Addendum No.: 1

Project Name: Mandeville Library Branch Renovations

PPSL – VSF# 23-33-5 ST. TAMMANY PARISH – MANDEVILLE BRANCH LIBRARY RENOVATIONS 844 Girod Street

ADDENDUM NO. ONE

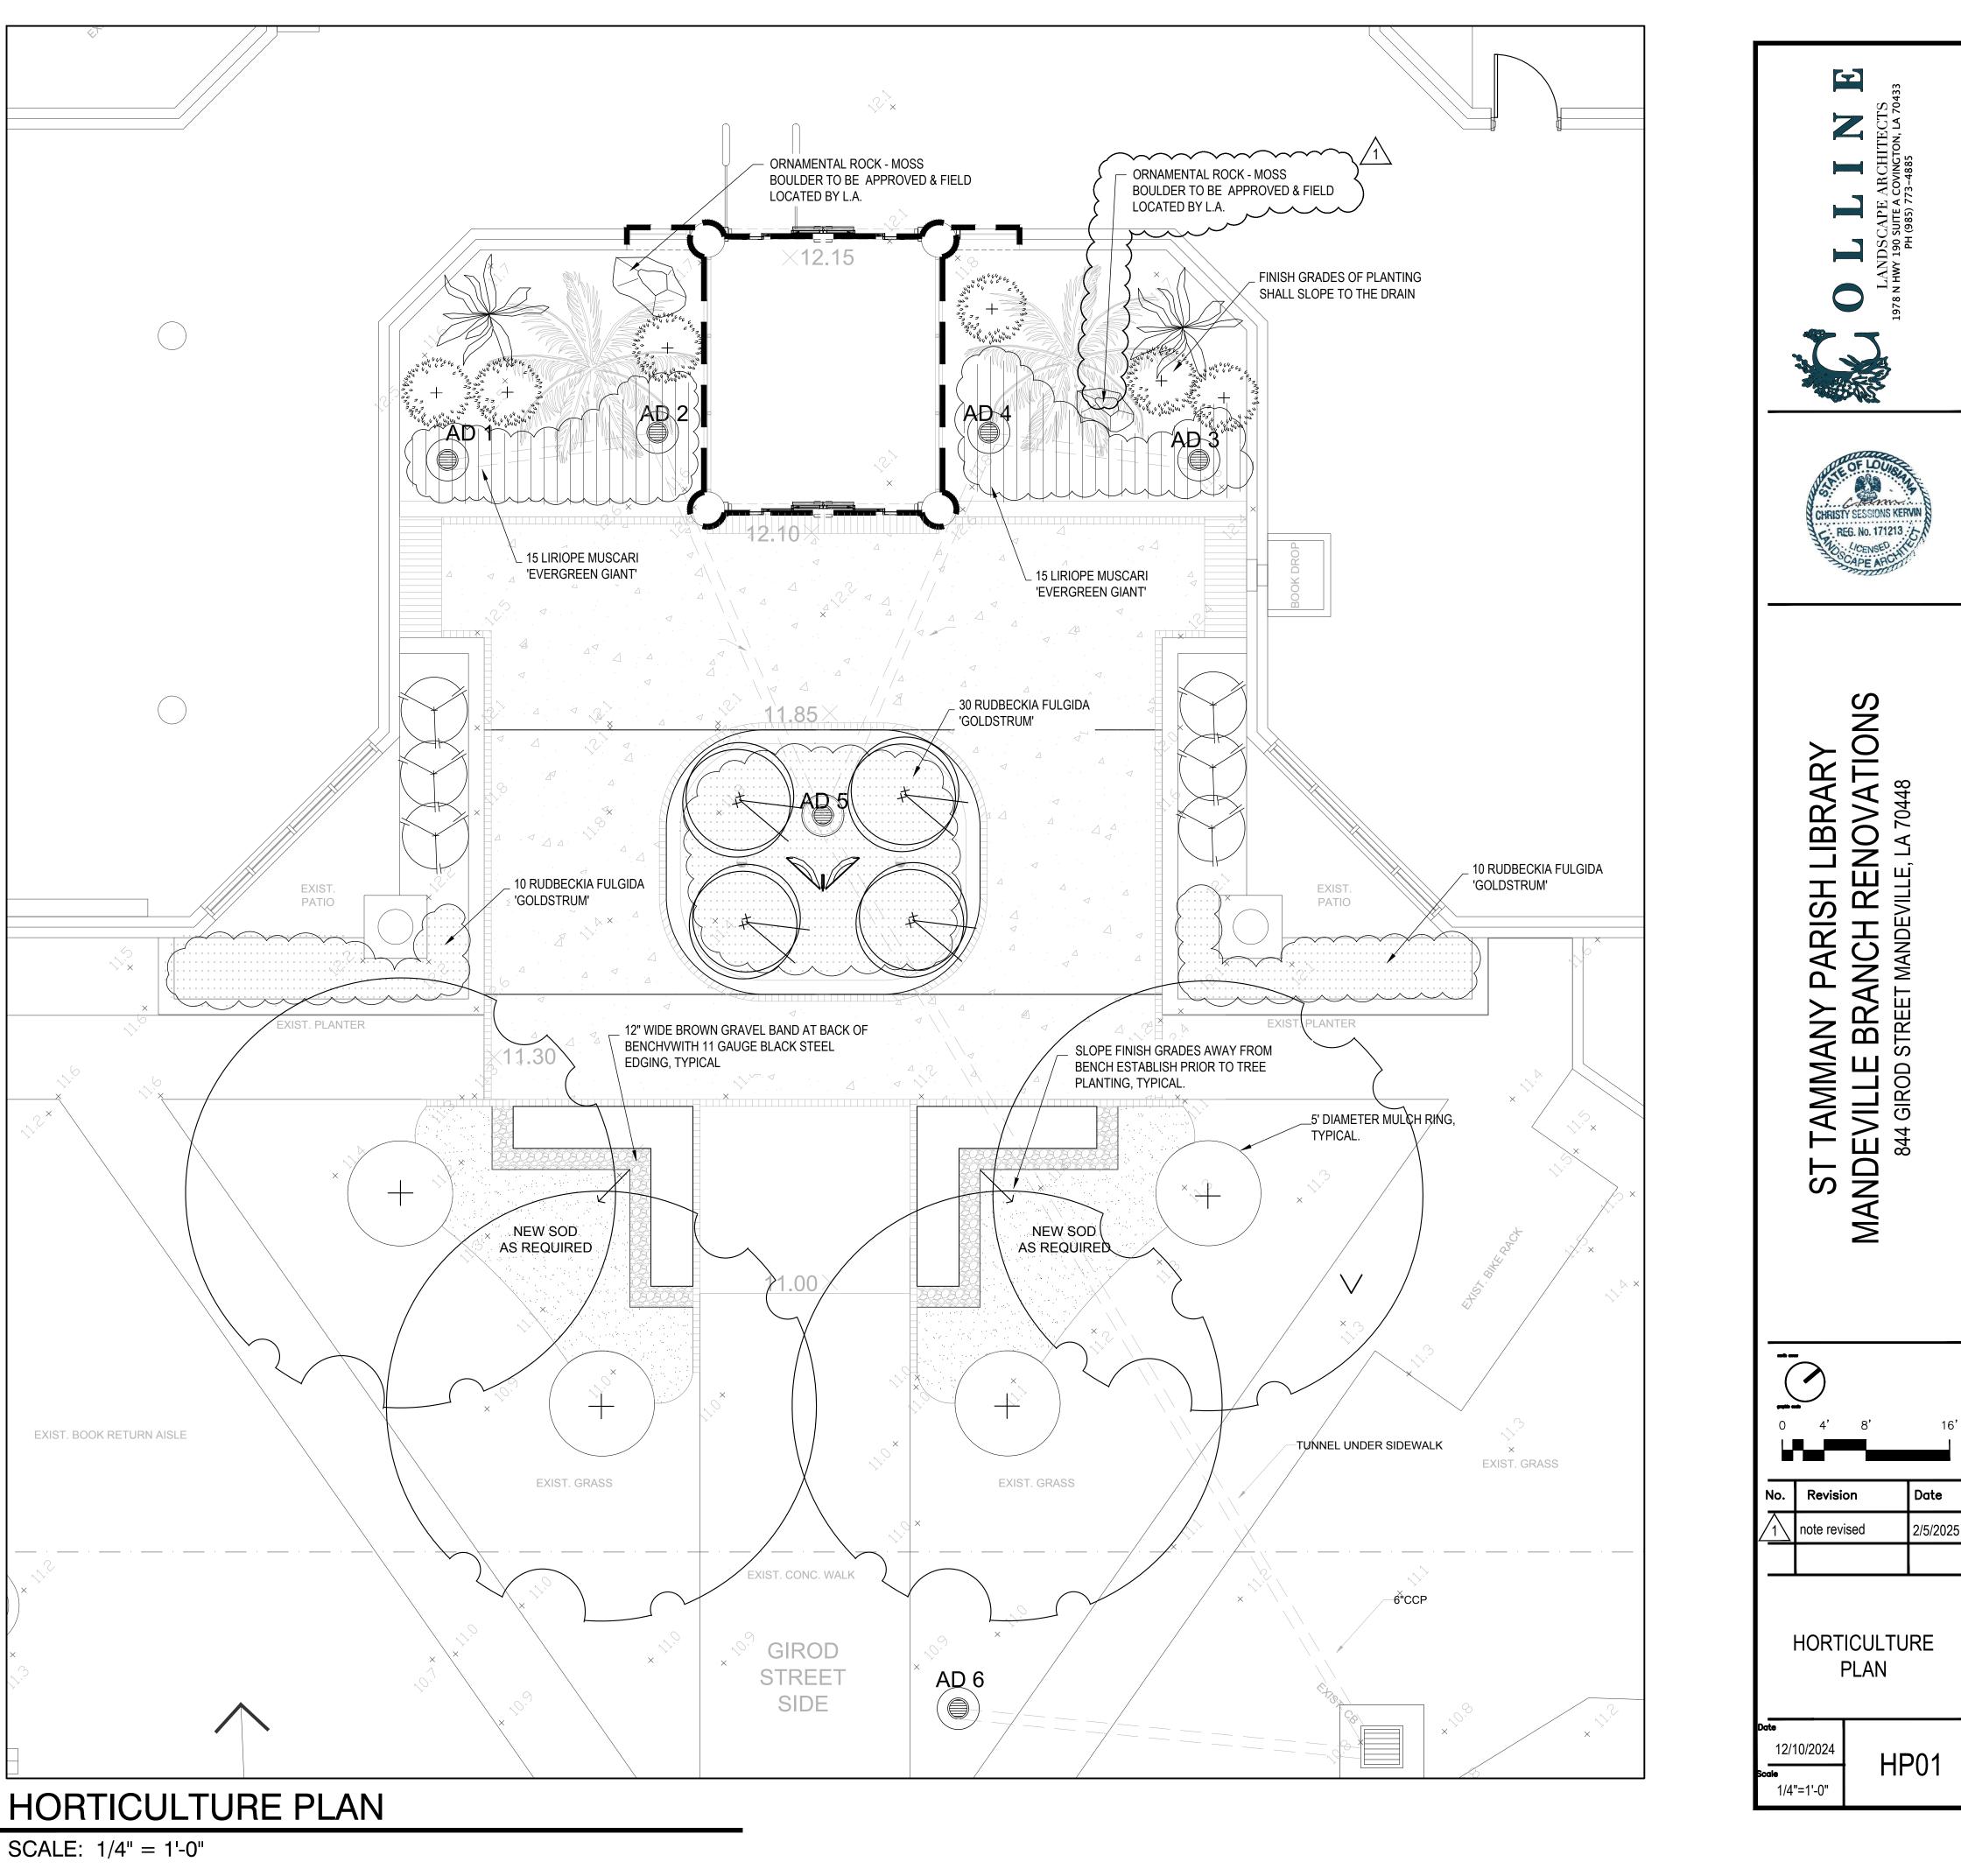
1.5 Boulder Note has been revised on **Drawing HP01**, see also **Drawing HP02** for clarifications to plant quantity and species pertaining to arrow.

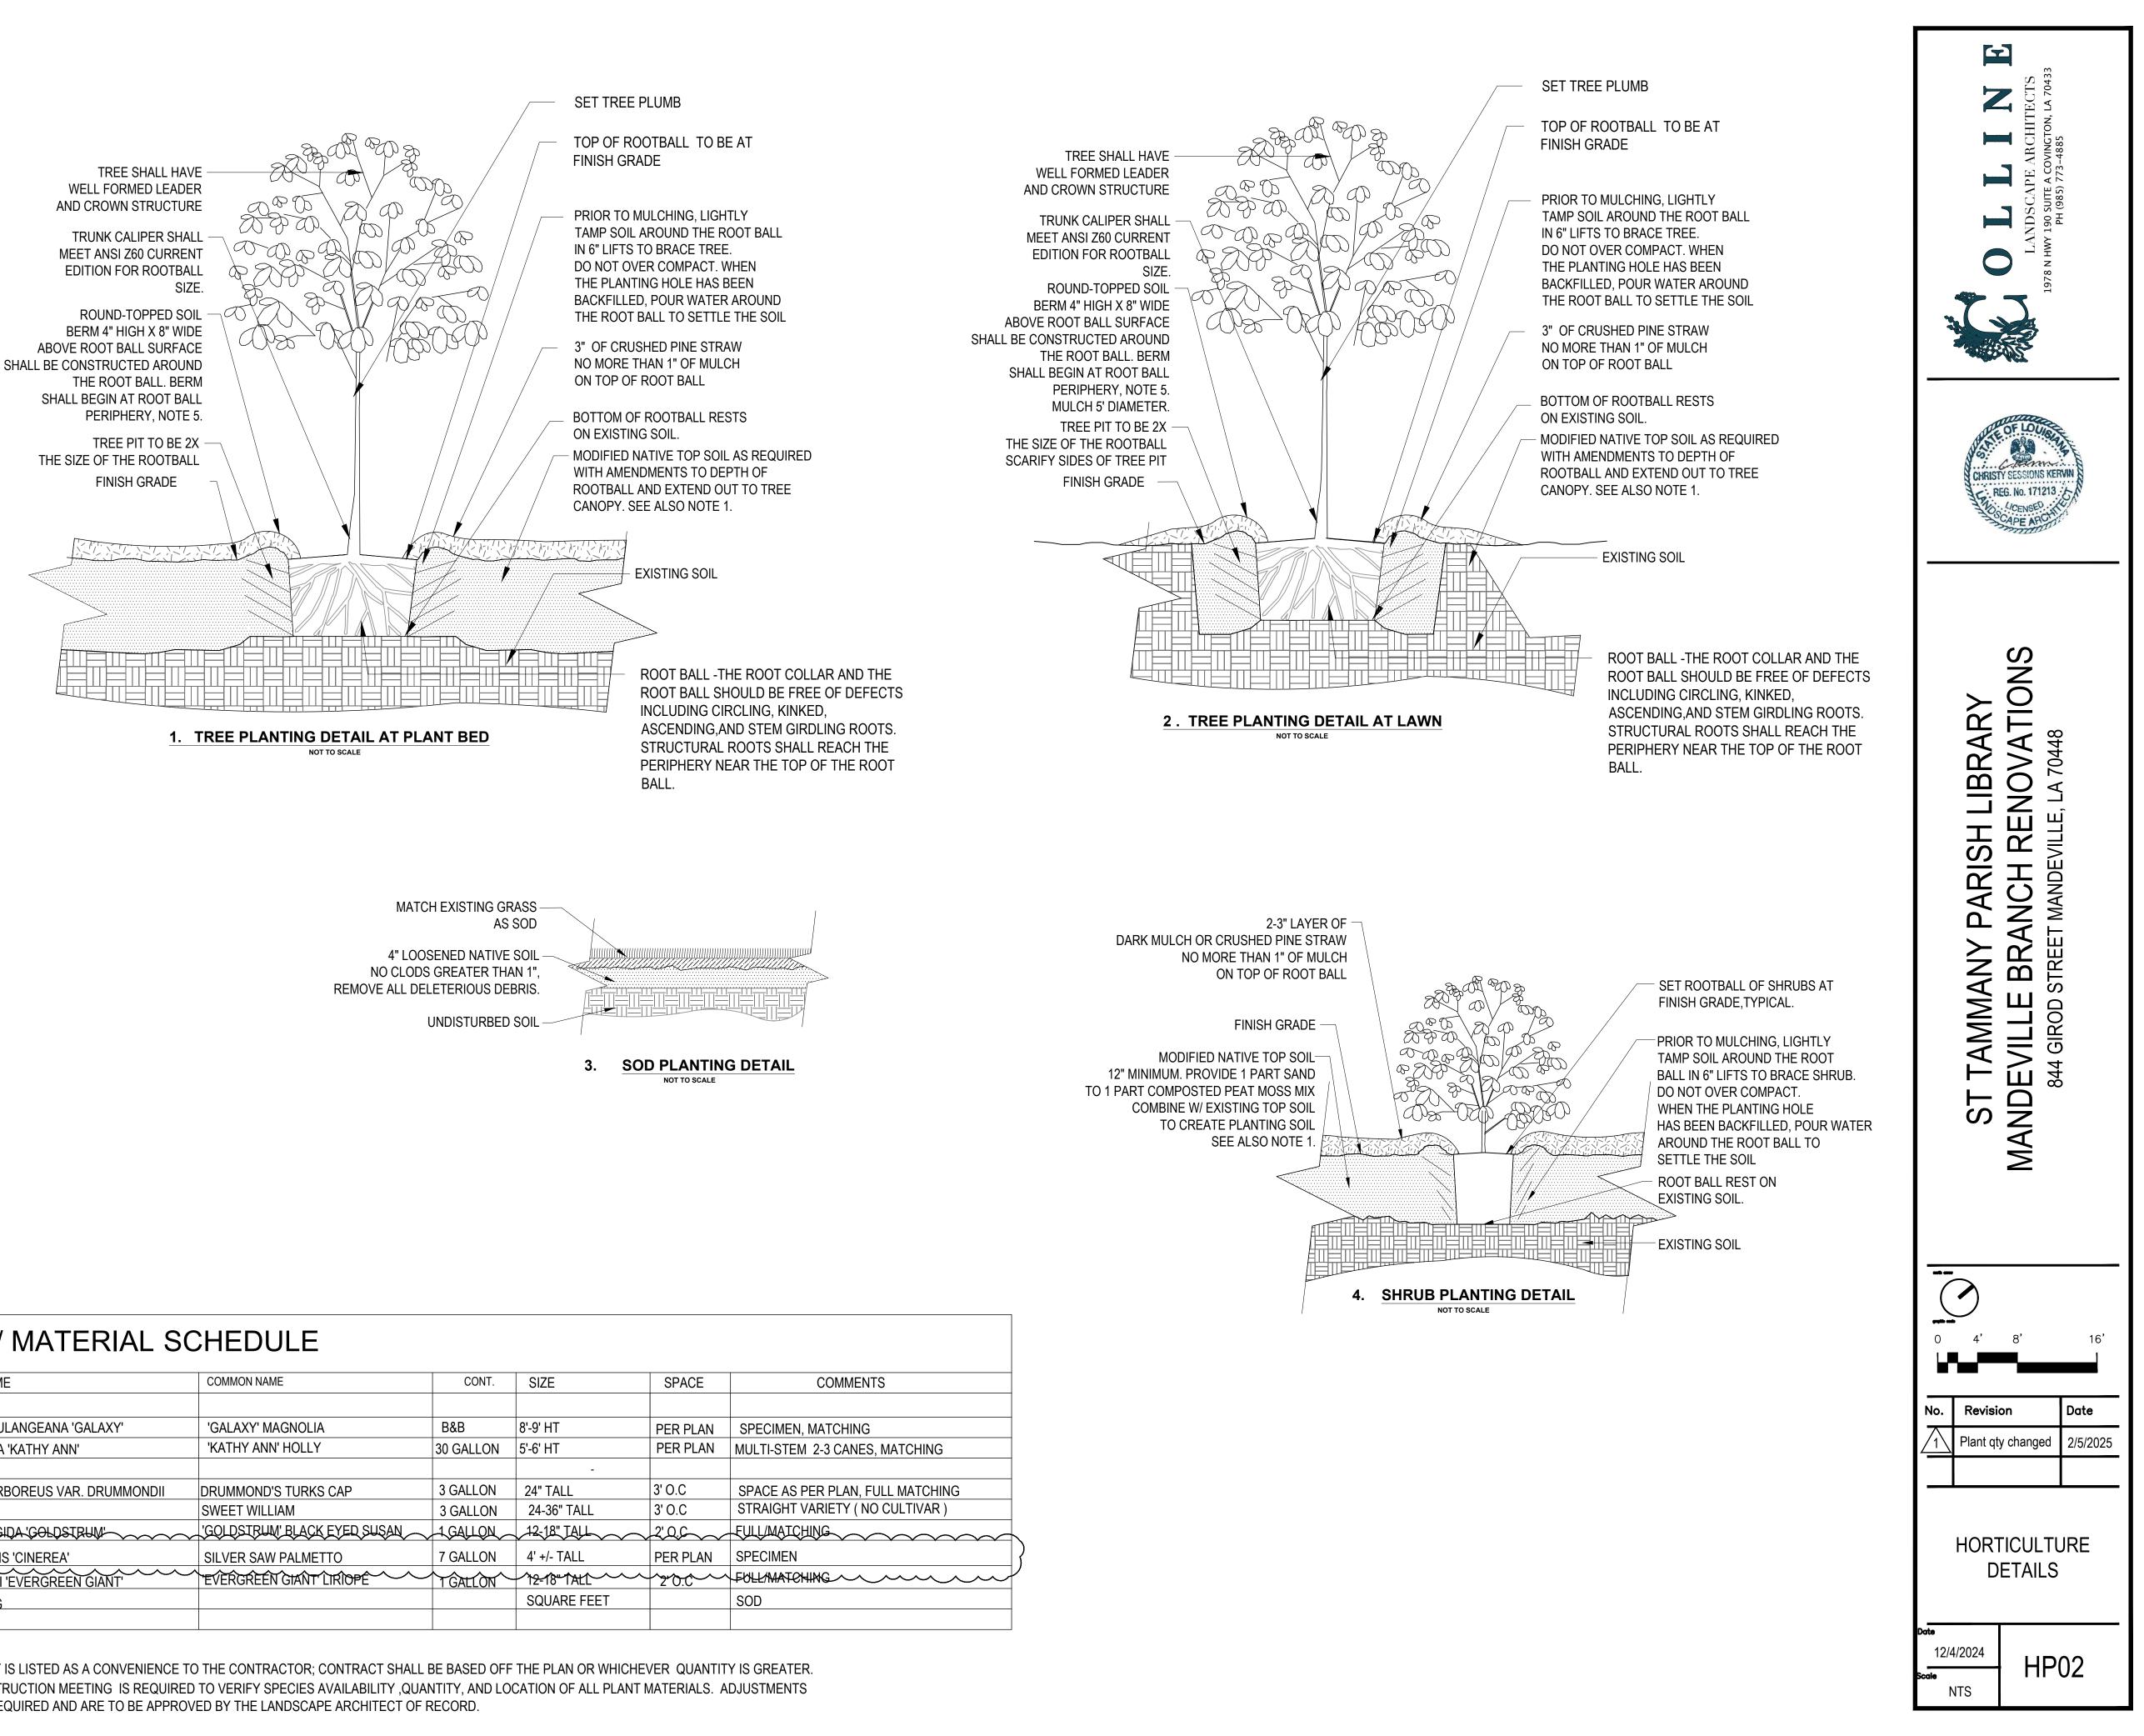
1.2 Drawing **HP02 Plant** and Material Schedule. Sod Hatch Area approximated to be 200 sf. Contractor is responsible for sodding all areas disturbed by construction activities which may be greater than the area hatched.

[200 SF	MATCH EXISTING			SQUARE FEET		SOD
